# CONSTRUCTION PLANS FOR T.F. STONE BUILDING ADDISON STORAGE ADDITION LOT 1, BLOCK A

*Reviews  
 SZ & P.L.  
 1/20/03*

*PLEASE RETURN THESE  
 CHECK REIMS w/ NEXT  
 SUBMITTAL!*

OEI Job No: 138-02

T.F. STONE COMPANIES, INC.  
T.F. STONE BUILDING  
LOT 1, BLOCK A, ADDISON STORAGE ADDITION  
**PAVING AND DIMENSIONAL CONTROL PLAN**  
ADDISON, DALLAS COUNTY, TEXAS

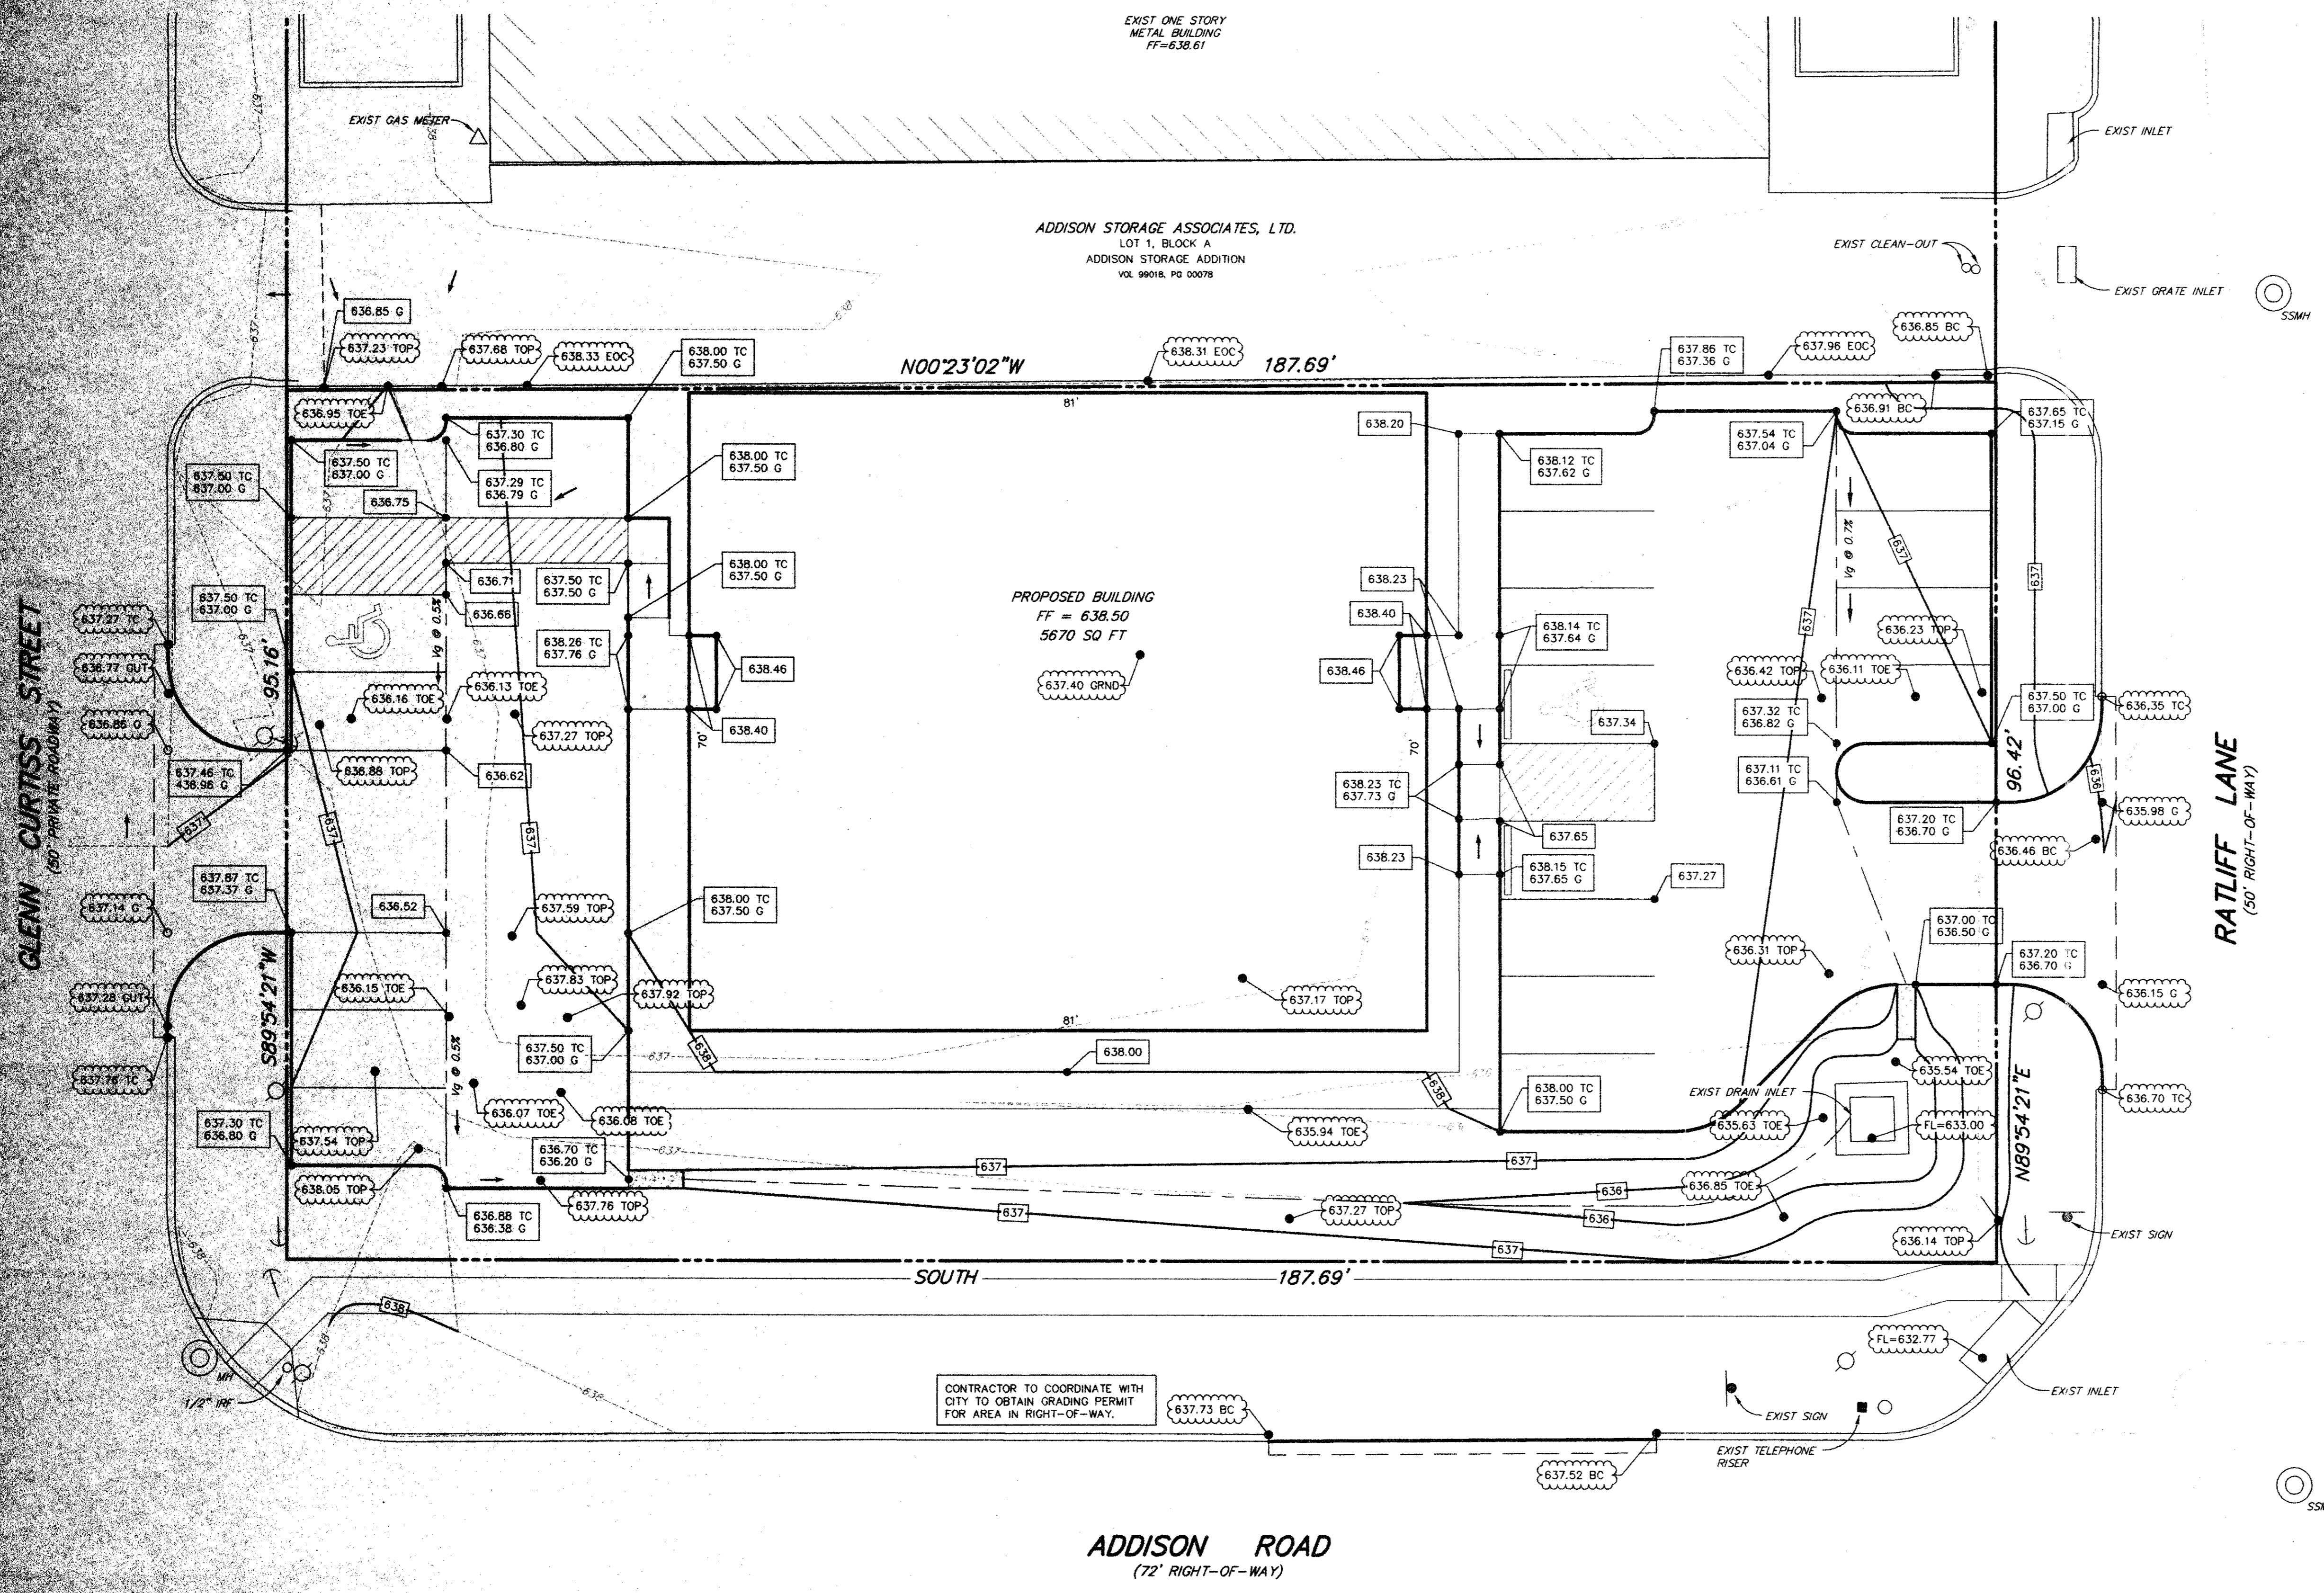
*We need to look at how we want the ramps to look here. There will be some curb removal.*

*Handwritten note: EITHER EXTEND THE SIDEWALK AROUND AS SHOWN, OR PLACE ADA RAMP!*

*Handwritten note: ADA STAIRCASE!*

*Handwritten note: Remove sidewalk*

**CONSTRUCTION DETAILS**

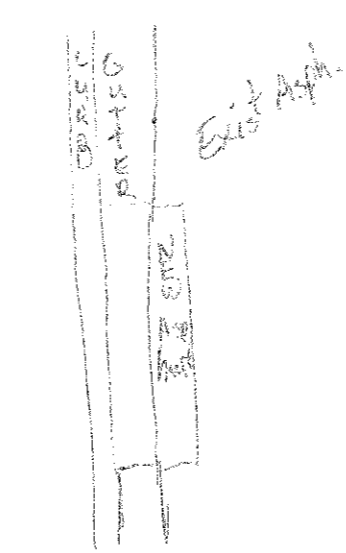
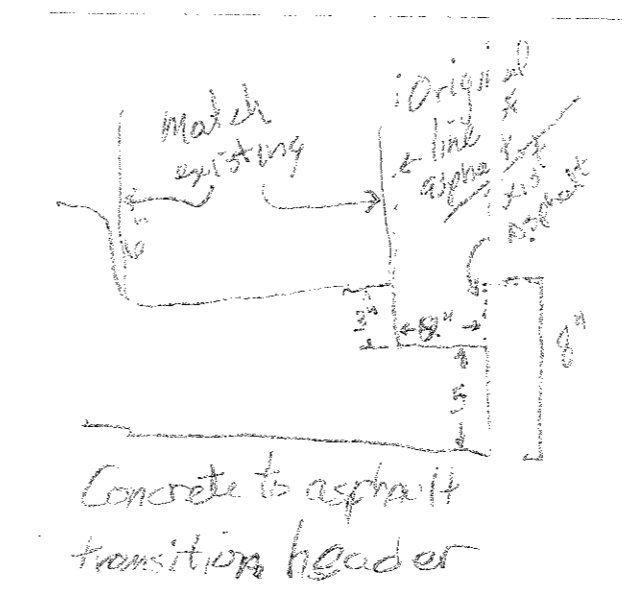
*Show concrete frame detail (s)!*

| LANDSCAPE PLAN  |          |          |                 |

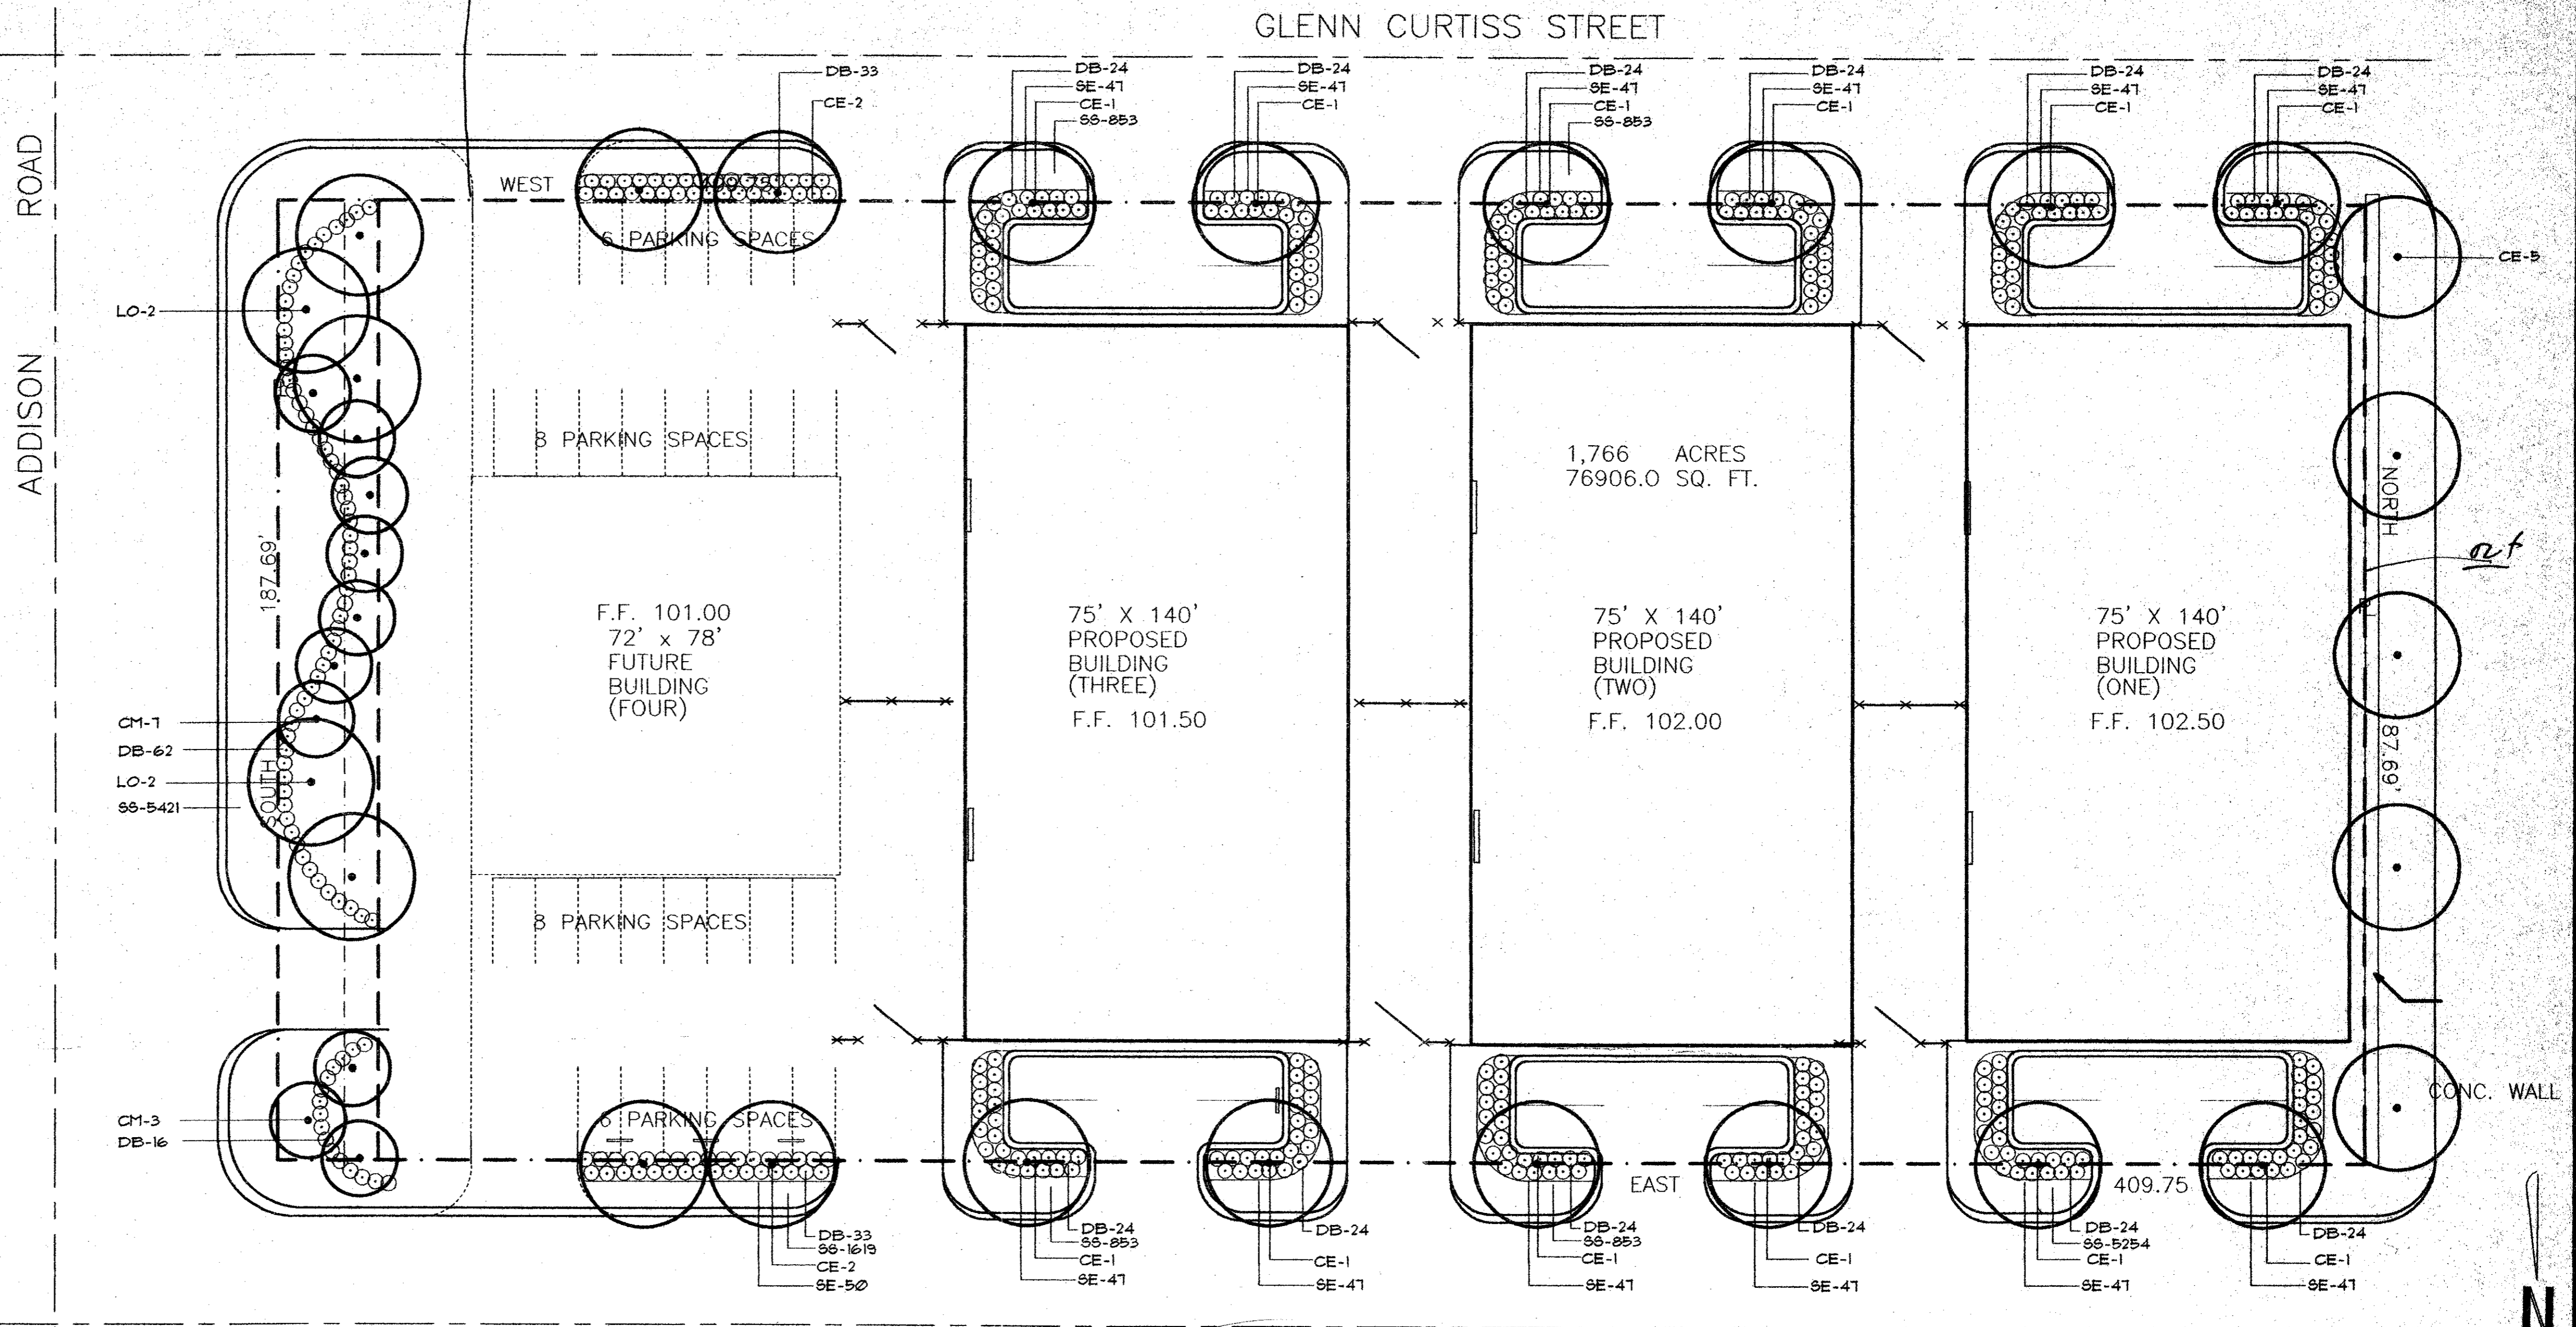
*THIS PLAN MUST  
 BE REVIEWED &  
 APPROVED BY  
 PARKS DEPT.*

| IRRIGATION PLAN   |                 |                |      |

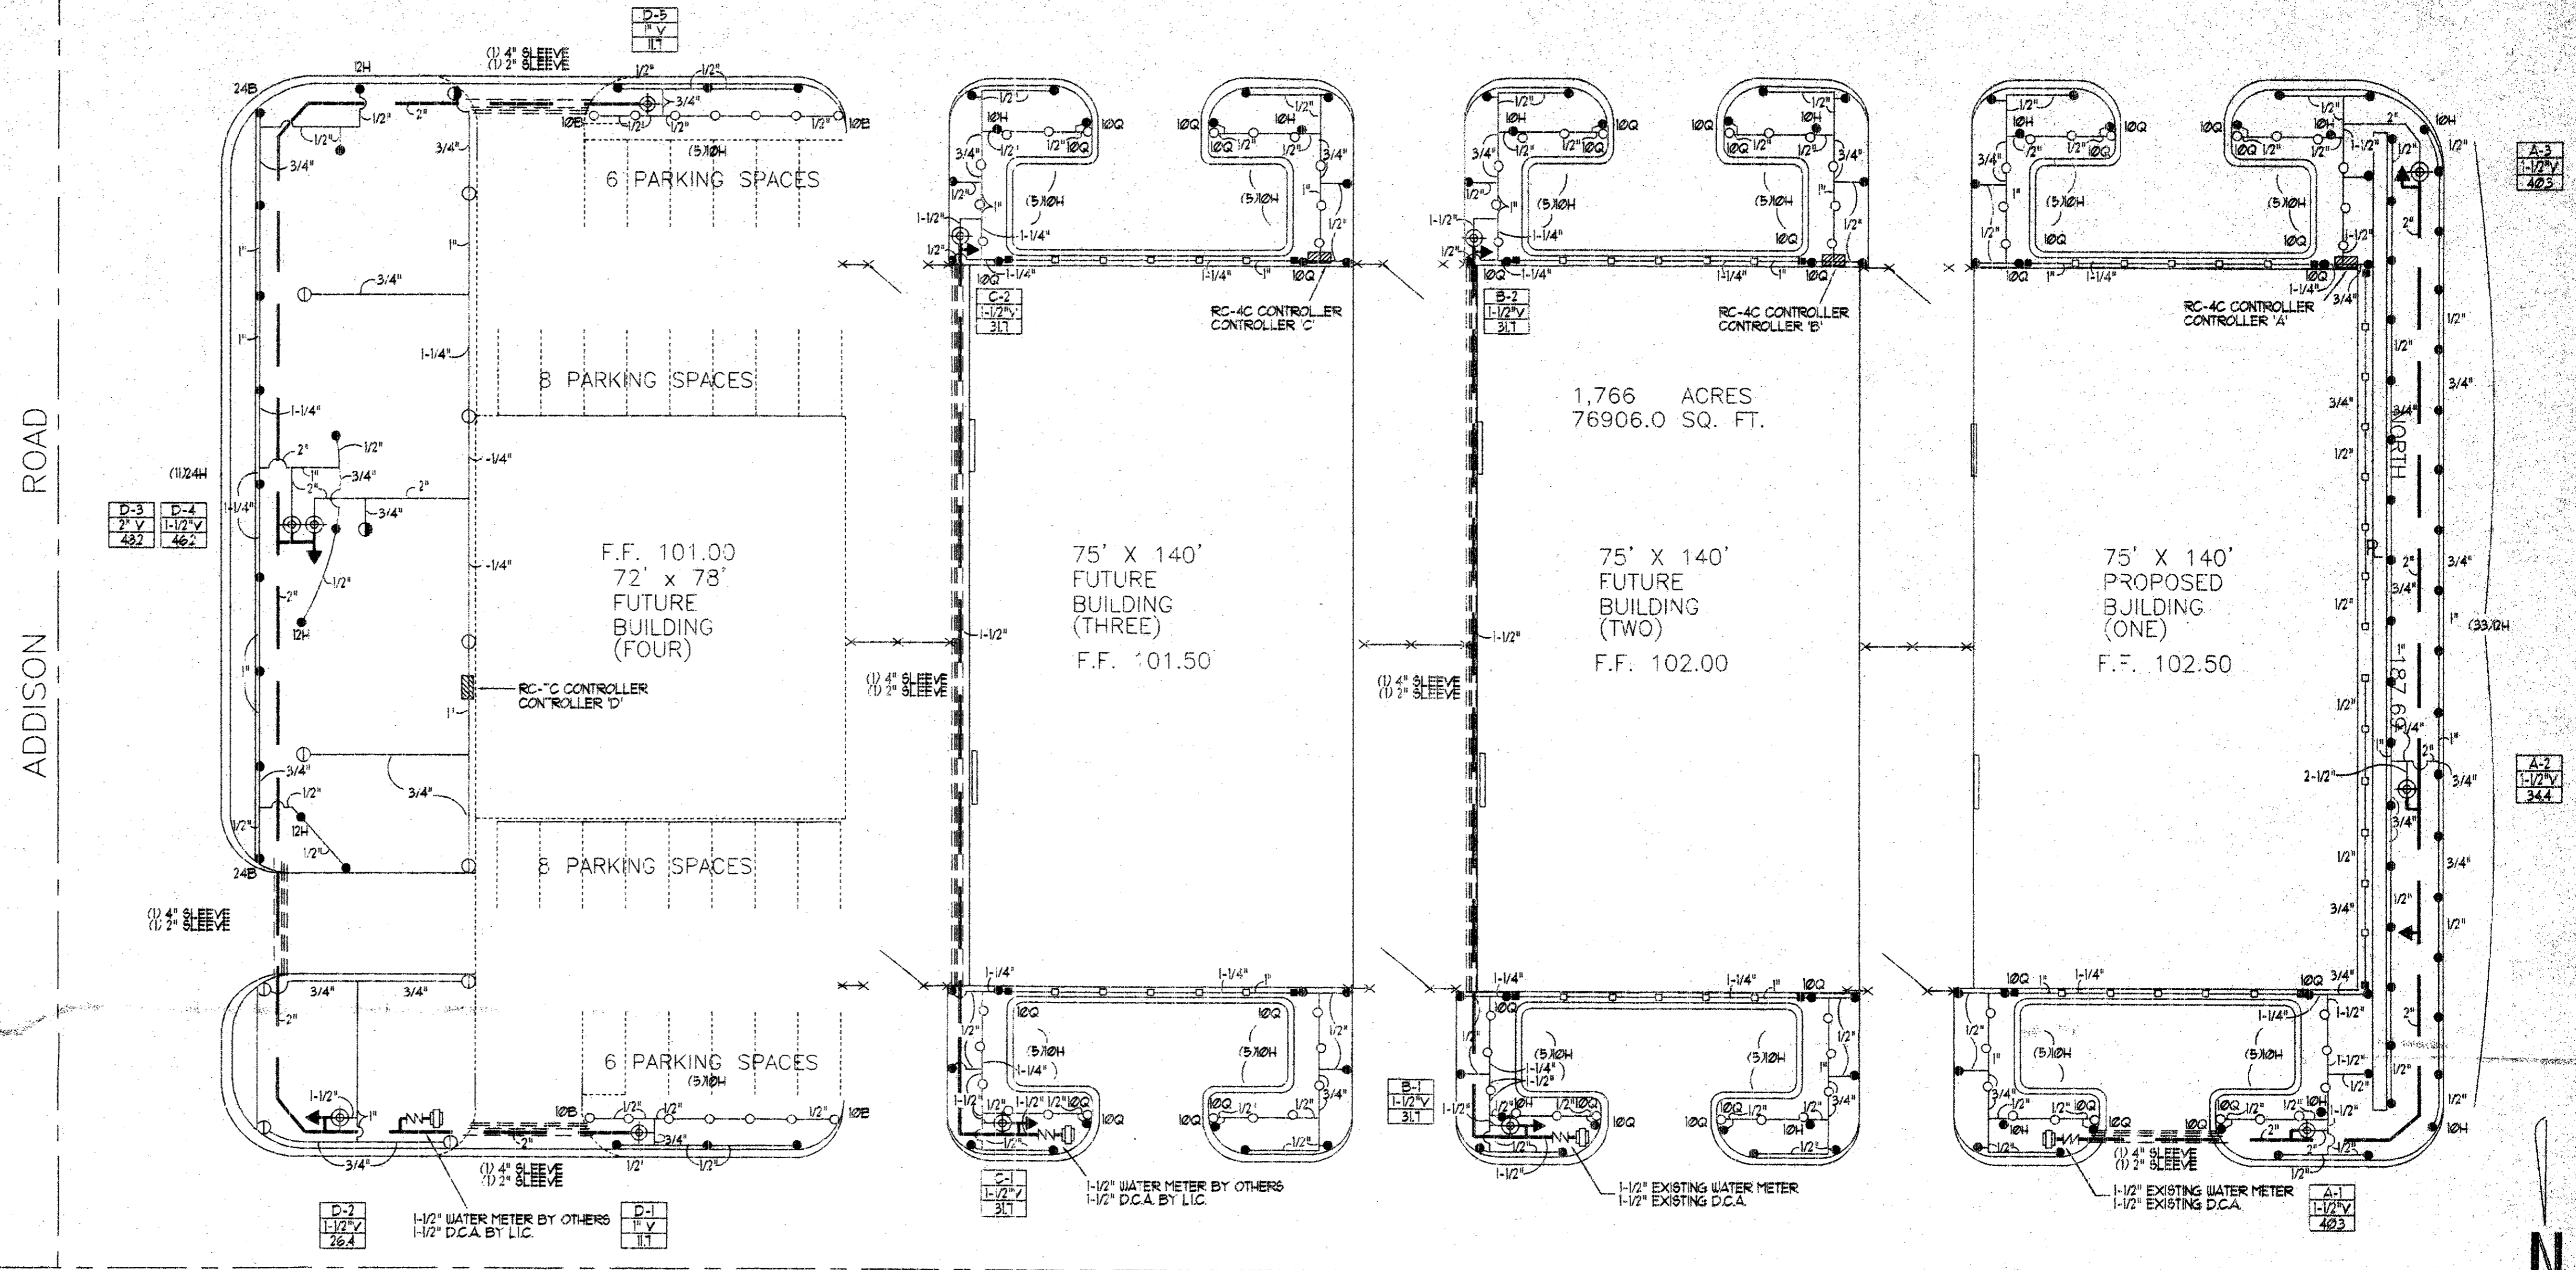
*THIS PLAN MUST BE REVIEWED & APPROVED BY PARKS DEPT.*
